MFN 06-262
Supplement 4

Subject: **Modified Reactor Building/Fuel Building Truncated Model,
SER-ESB-038 Rev. 5**

**Shimizu Engineering Report SER-ESB-038, Rev. 5,
“Modified RBFB Truncated FE Model Analysis Data,”**

Project	General Electric Company ESBWR Project	Shimizu Document No.	SER-ESB-038
Title	Modified RBFB Truncated FE Model Analysis Data	Rev.	5
		Issued Date	9/22/06
		Revised Date	1/9/07

Figure C-29 Element Forces Comparison NASTRAN to ANSYS (Basemat Section A-A: Axial Force [MN/m])

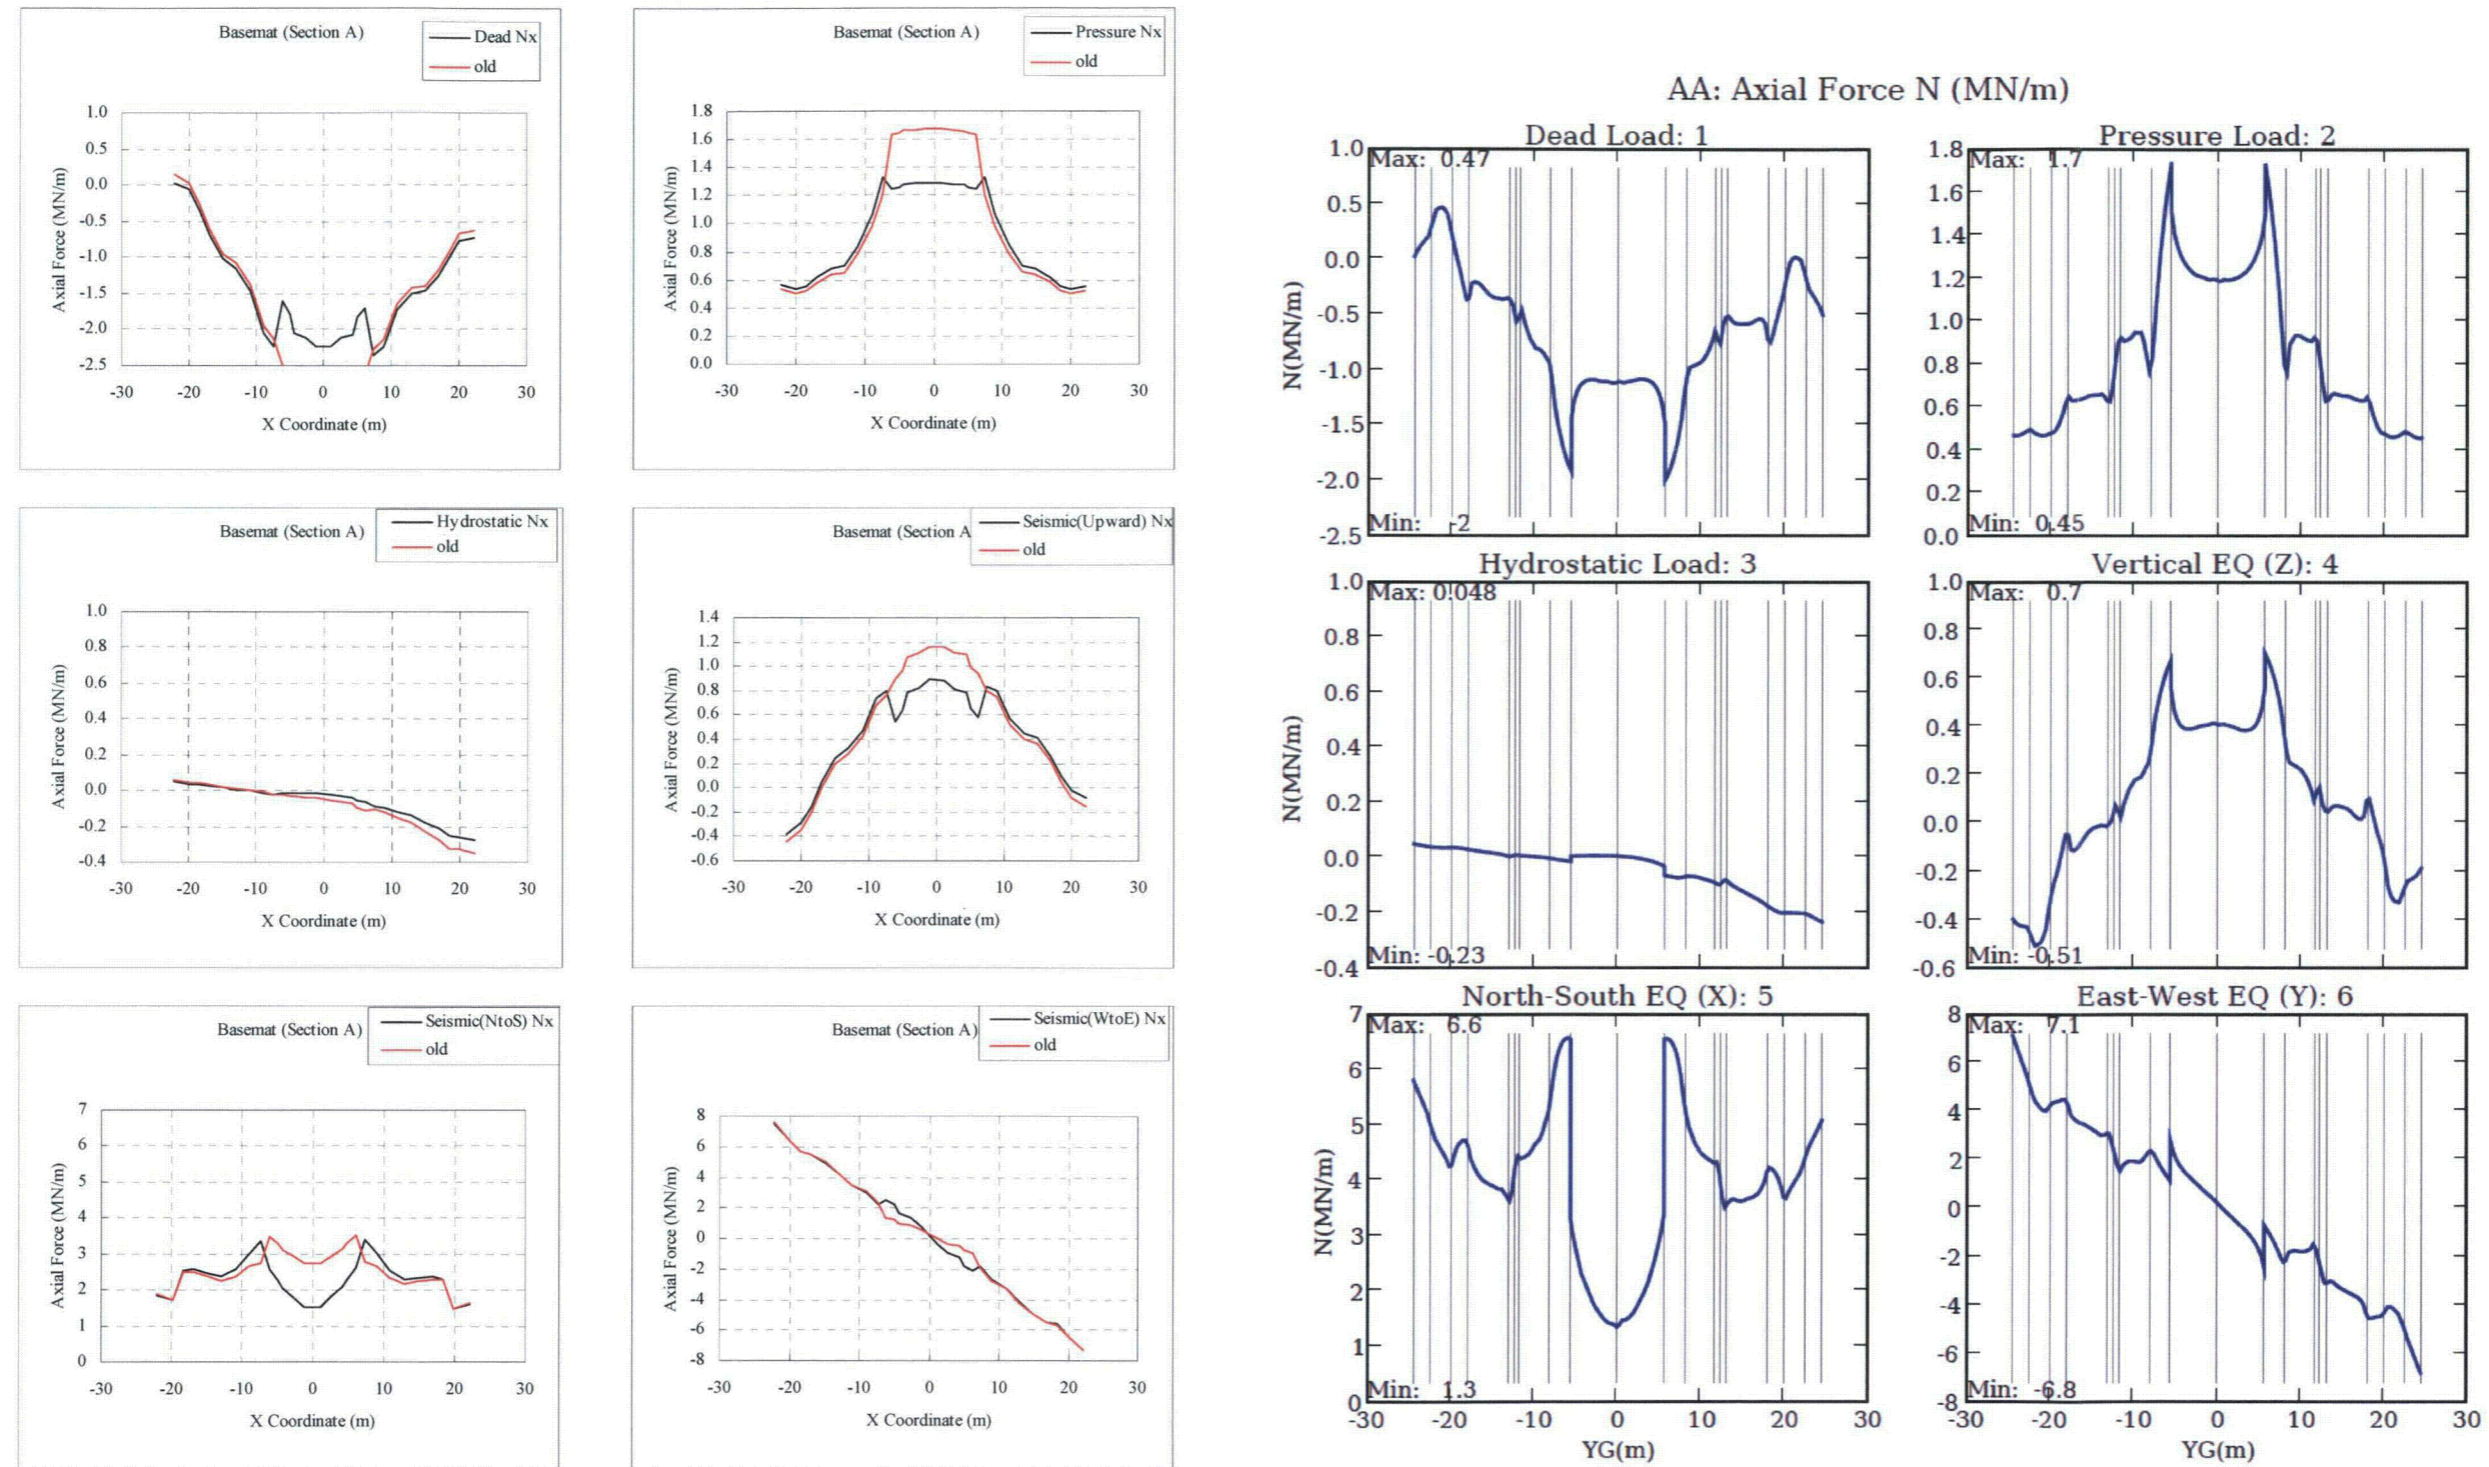
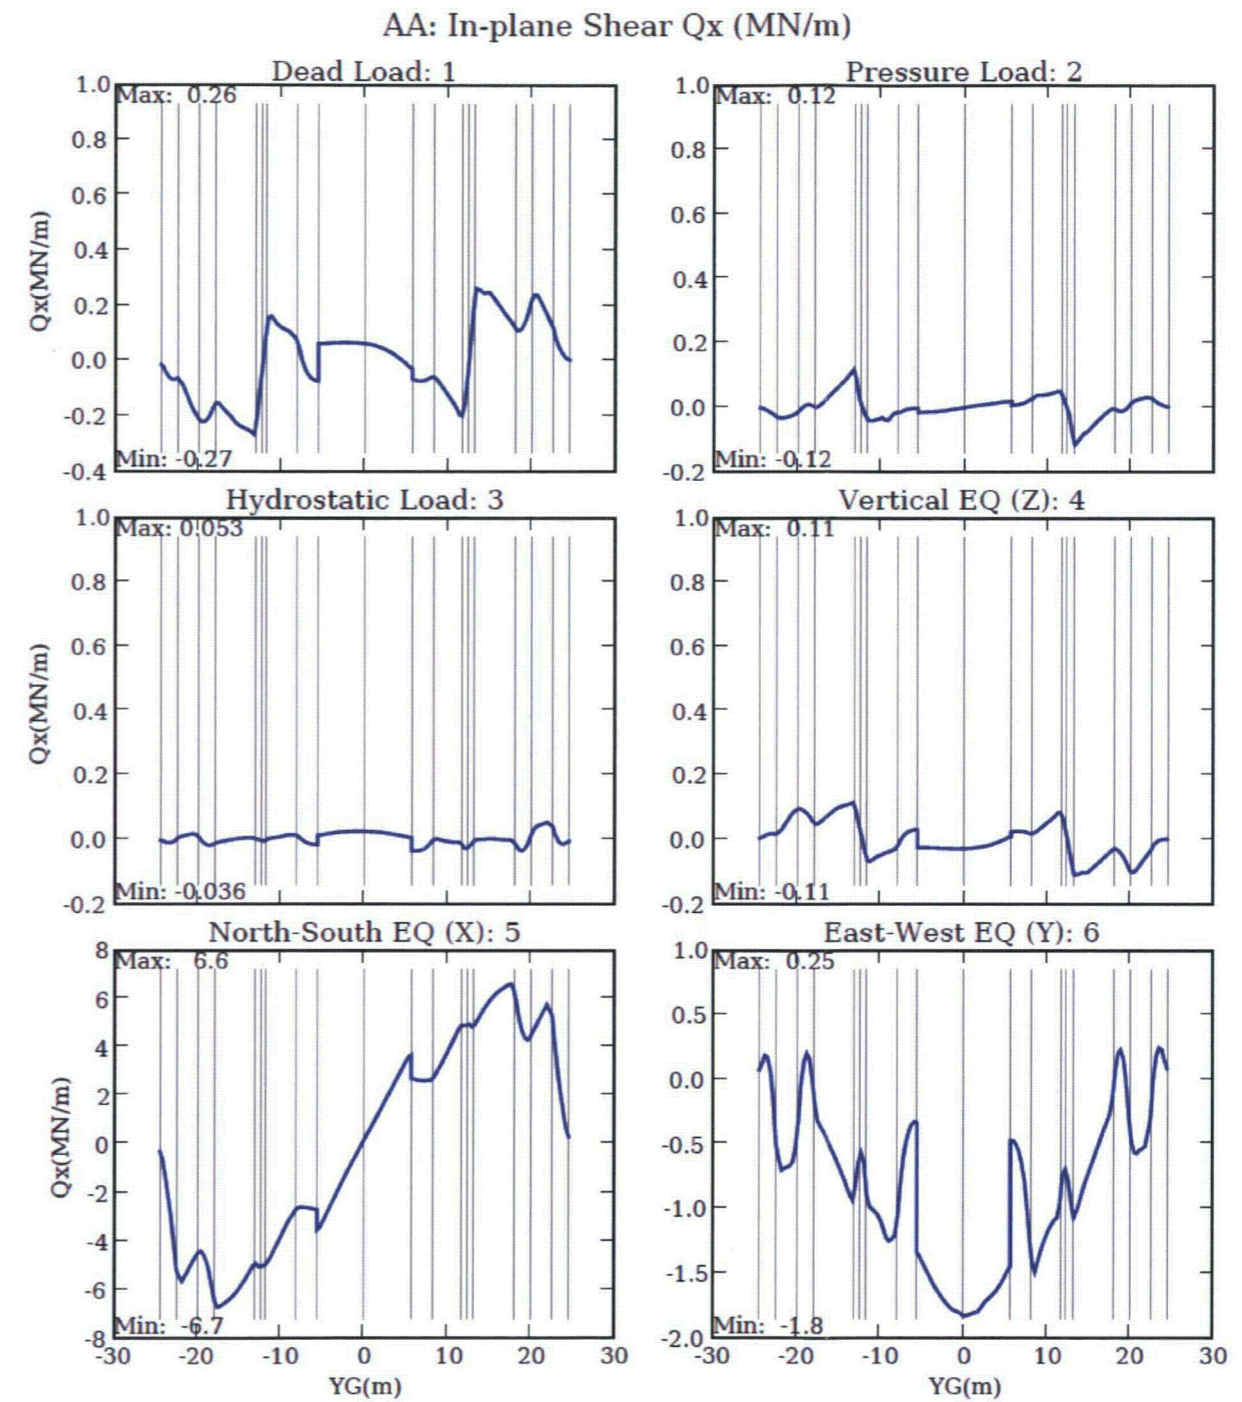
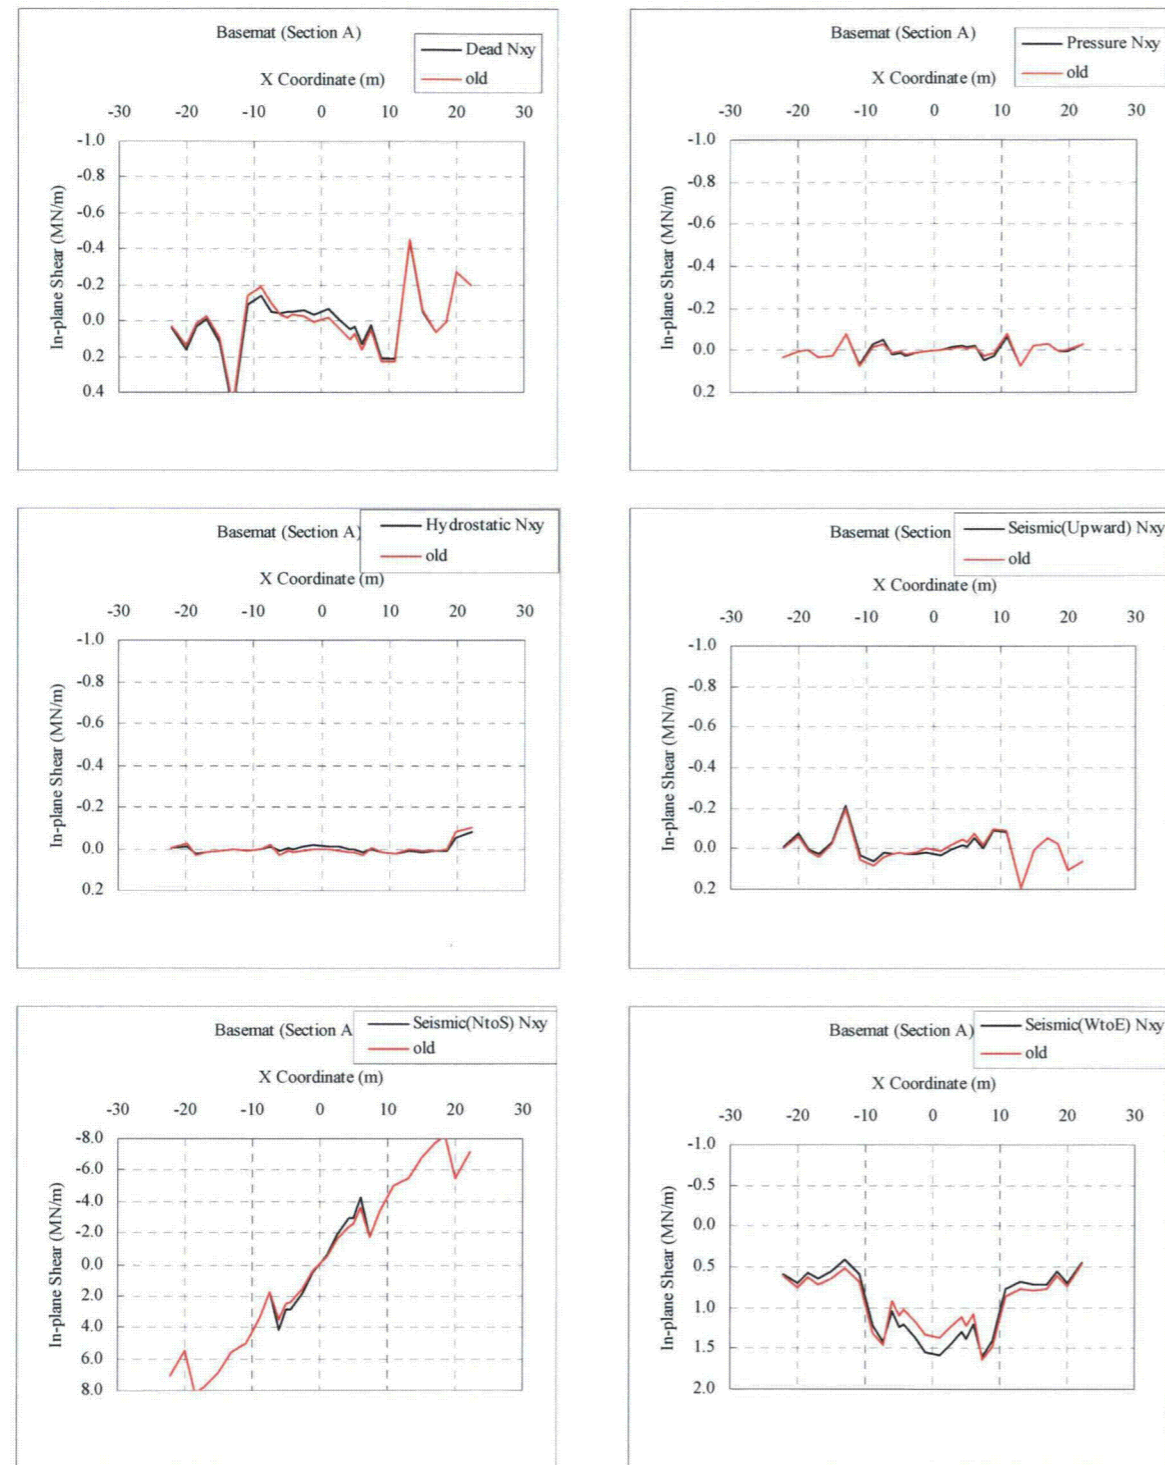
- iii) *The differences of magnitude of forces appeared on basemat inside pedestal:* The result of re-analysis using the updated model shows better agreement. In case of seismic load the magnitude of forces has to be re-compared because BNL's soil spring may not be adequate as pointed out above 3).

- iv) *The differences of magnitude of forces appeared on outer wall of Fuel Storage Pool (FSP):* For the out-of-plane shear forces and moments on RA and F3 wall located around FSP in case of Hydrostatic load, BNL's results are lower than those of GE. GE assumes the some part of differences comes from the difference of estimation levels between both models as pointed out above 8). In order to have a better understanding of the differences, GE would like to request BNL to confirm the input data for Hydrostatic load.
